Nebraska Public Power District

Subject: Relief Request RP-04, Revision 1.

RELIEF REQUEST RP-04, REV. 1

Fig. 4 General machinery vibration severity chart

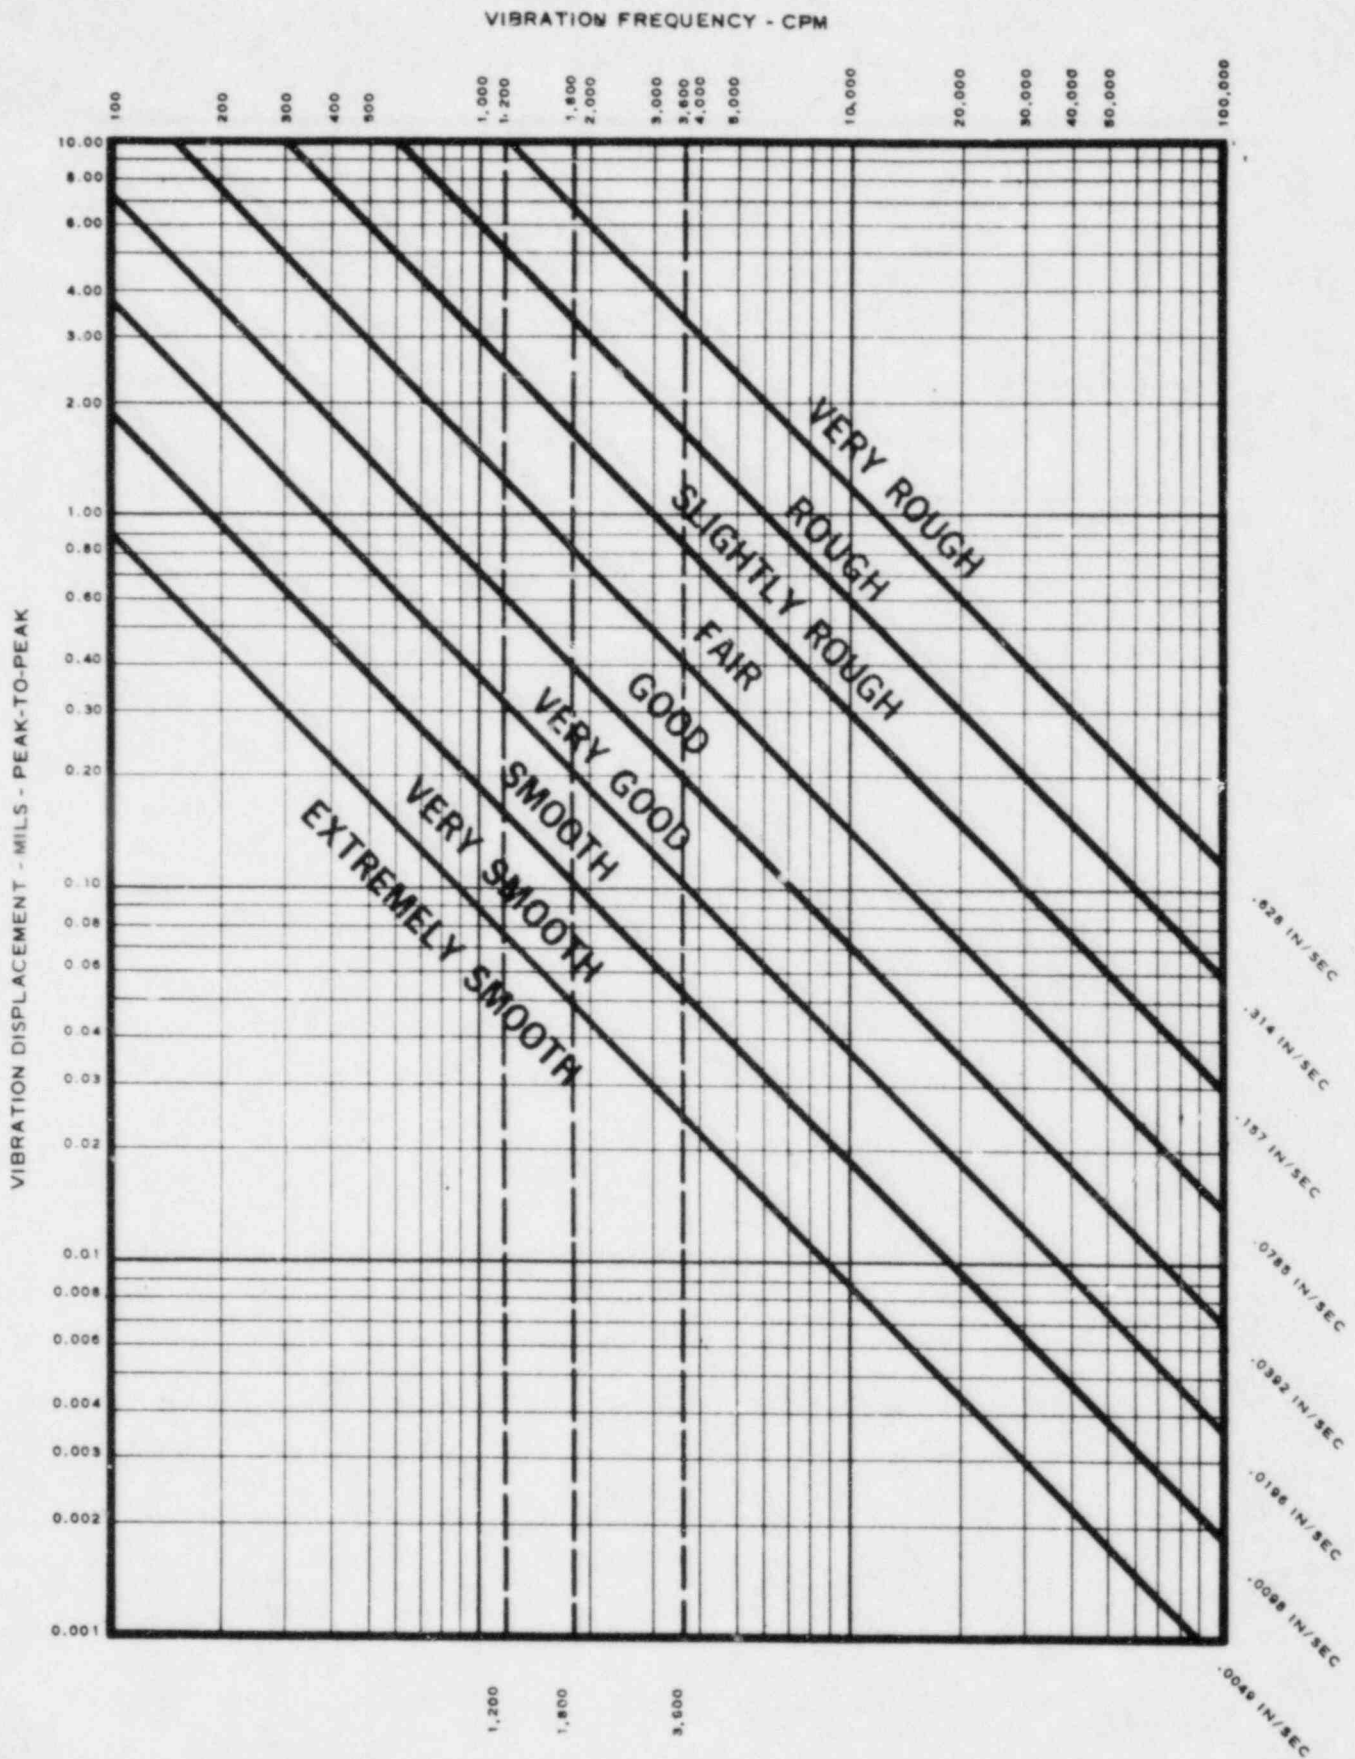
Acceptable, Alert, and Required Action ranges will be established using a combination of the "General Machinery Vibration Severity Chart" published by the American Society of Mechanical Engineers (67-PEM-14), and from what has proven by twelve years of plant operating experience to be satisfactory. See Page 3 for chart. Accordingly, the specific ranges will be as follows:

The allowable ranges of vibration as given in Table IWP-3100-2 are based on a reference value. The District's proposed method uses absolute ranges which are independent of the reference value.

Again, this is based on what has proven by experience to be satisfactory. For example, reference values for the subject pumps at Cooper Nuclear Station typically range from 0.10 in/sec to 0.15 in/sec. An increase in a vibration level from 0.10 in/sec to the upper limit of the proposed acceptable range of 0.235 in/sec is a 135% increase in vibration severity which is commensurate with allowable increases shown in Table IWP-3100-2.

Acceptable Range: $V < .235$ in/sec
Alert Range: $.235$ in/sec $< V < .450$ in/sec
Required Action Range: $V > .450$ in/sec

Acceptable Range: $V < .235$ in/sec
Alert Range: $.235$ in/sec $< V < .450$ in/sec
Required Action Range: $V > .450$ in/sec
